September 20, 2021

Subject: Aspire Subdivision Traffic Impact Study
Southeast quadrant of 118th Street and Amole Mesa Ave.,
North of NM 500
Albuquerque, Bernalillo County, New Mexico

This letter is to inform you that the **FINAL** Traffic Impact Study (TIS) for the proposed Aspire Subdivision located on north of NM 500 on the southeast quadrant of 118th Street and Amole Mesa Ave. dated June 2021 has been reviewed.

Figure 15. Unser Blvd Roadway Re-Configuration Concept Drawing

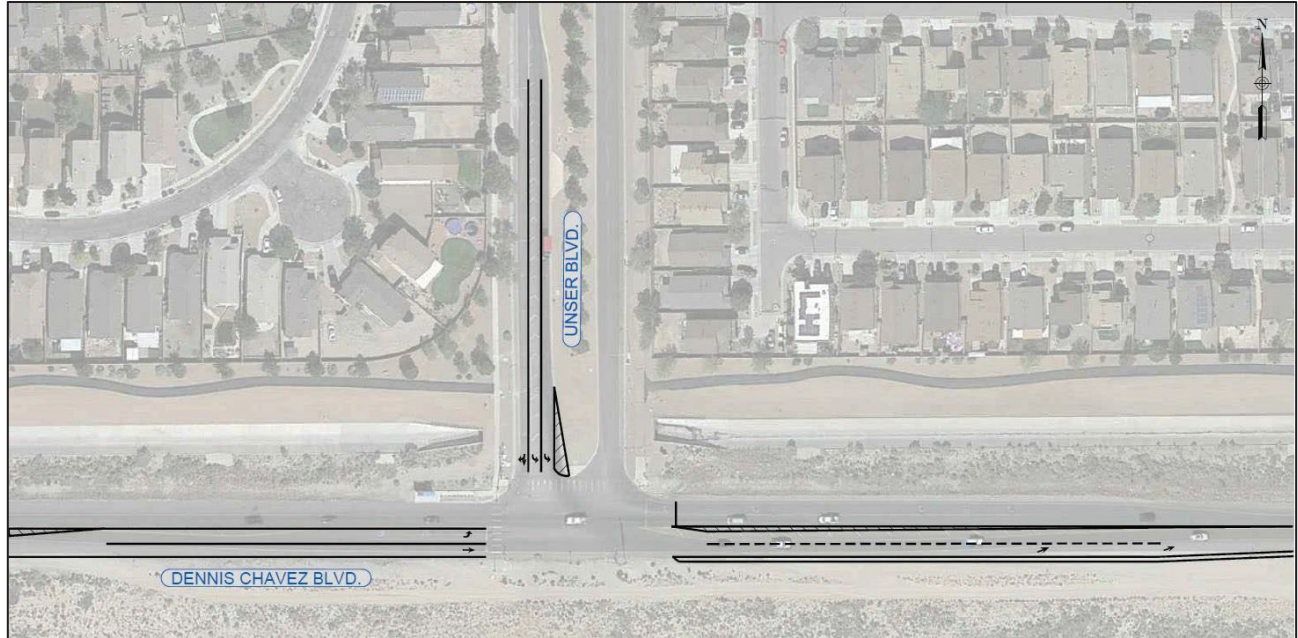
1. At NM 500 and Unser Blvd., the development shall install the following off-site improvements:
 - a. A second southbound left turn via eradication and restriping.

- b. A second receiving through lane on the eastbound departure side of the intersection at a length of 550-feet including 170-foot taper via restriping and pavement extension.

- c. Extend the eastbound left lane via eradication and restriping.
2. At NM 500 and NM 45, the development shall install the following off-site improvements:

Figure 16. Coors Blvd Roadway Re-Configuration Concept Drawing

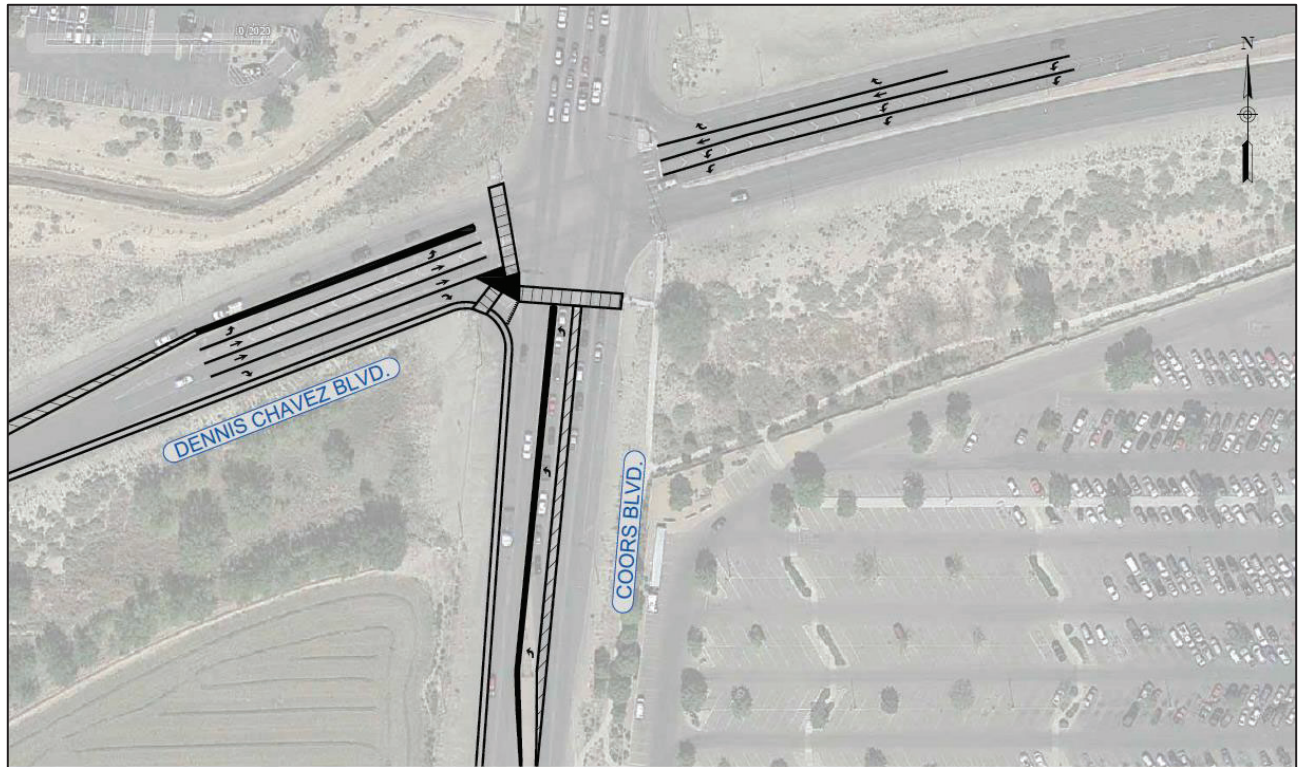
- a. Extend the northbound left lane on NM 45. Split storage lane with La Monica Blvd.
 - b. Install second westbound left lane via eradication of hatching and restriping.

- c. Install second eastbound through lane via eradication of hatching and restriping. Eradication of all eastbound striping is expected with this effort.

- d. Install dedicated eastbound right lane via eradication and restriping.

- e. Signal improvements associated with the additional second westbound left resulting in conversion of westbound and eastbound left turns converted from protected-permissive to protected left turns only.
 - f. Signal improvements to include retiming of the signal with restriping improvements.
3. The NMDOT shall provide final approval on the design for the offsite improvements. The developer shall agree to incorporate all the comments requested by the NMDOT.
